Proposed Revisions to a Standard Plans Index

Index Number: 700-090

Index Title: DYNAMIC MESSAGE SIGN WALK-IN

SHEET
4 of 5

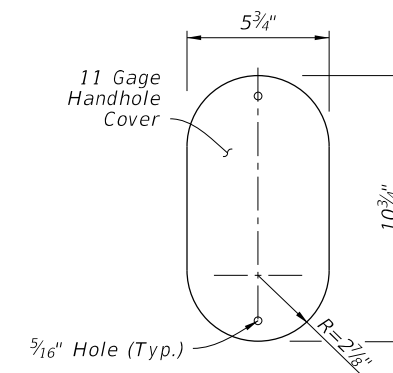
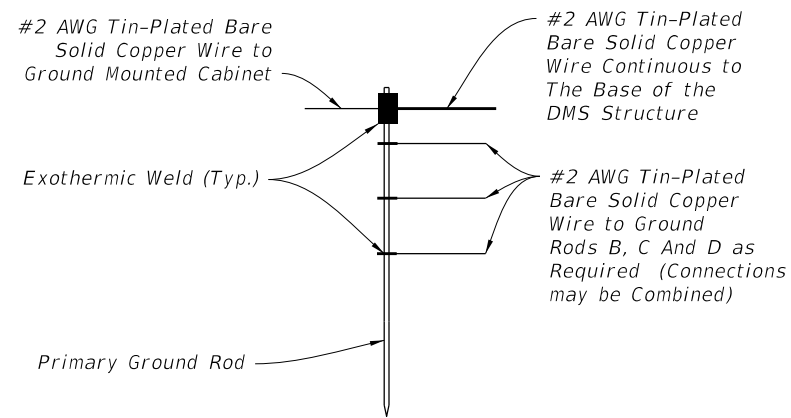
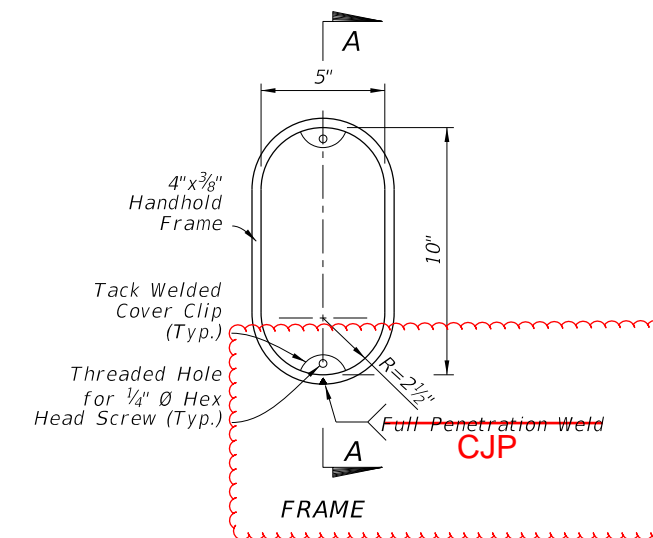
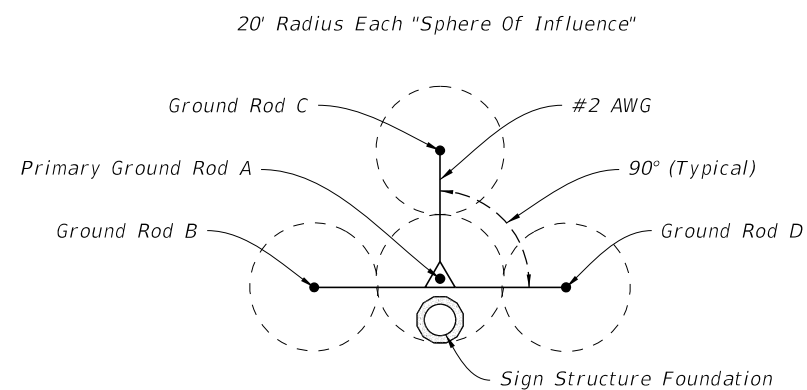
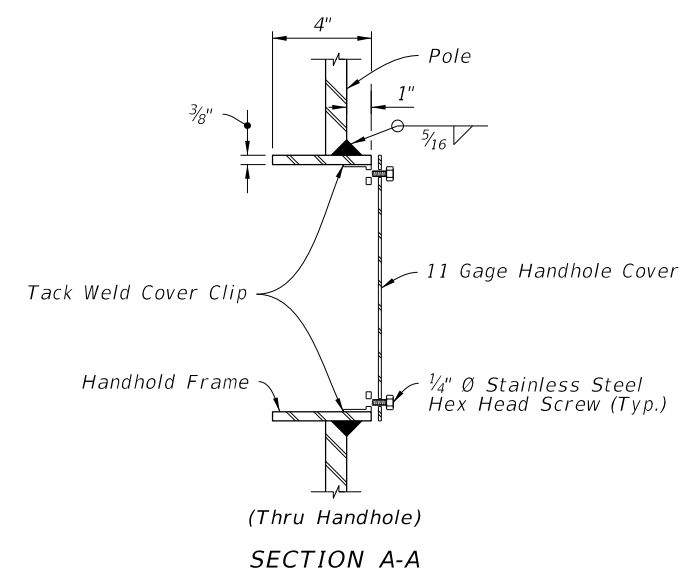
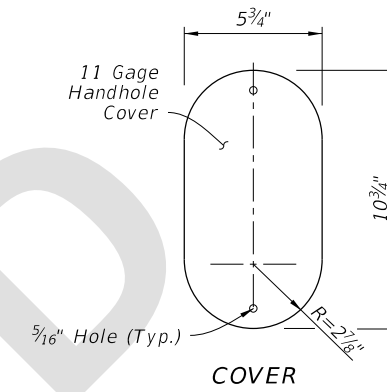
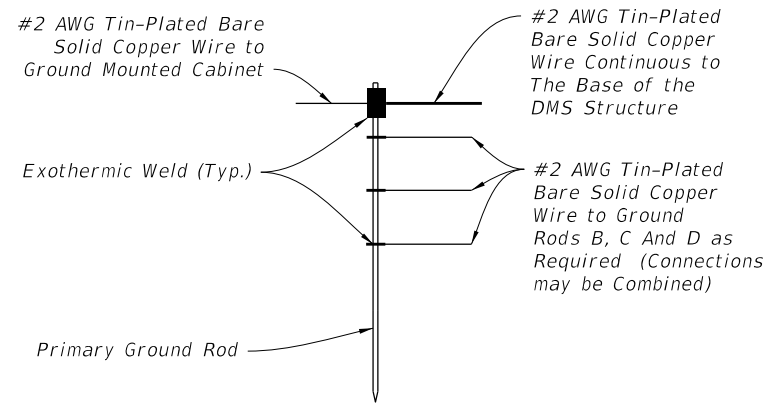
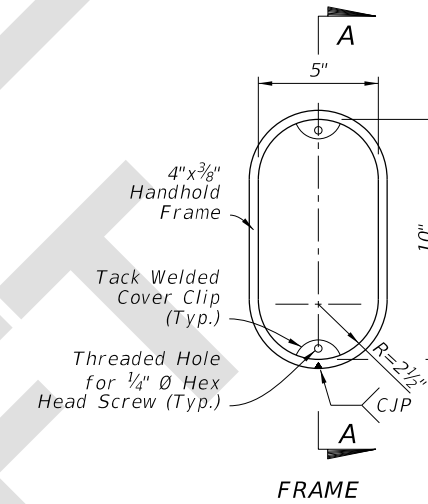
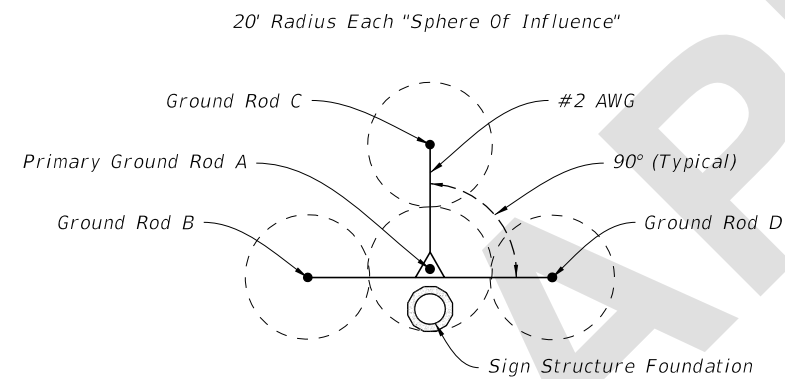
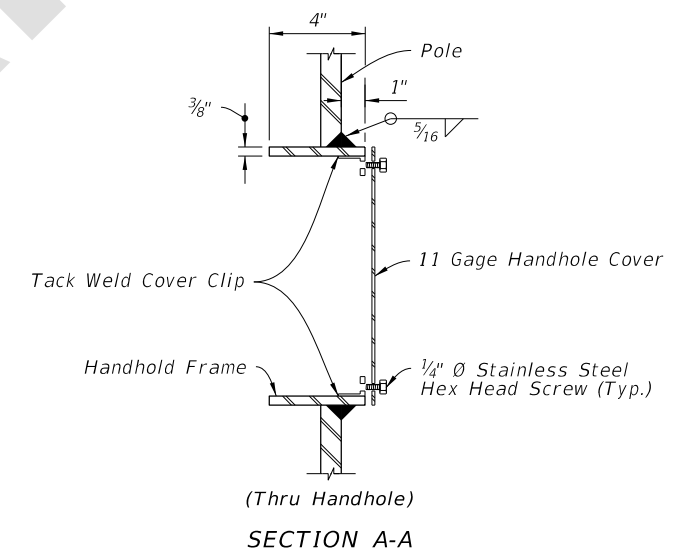
Sheet 4: Changed weld detail to say "CJP."

Sheet 4: Changing non-standard language to standard language consistent with AWS.
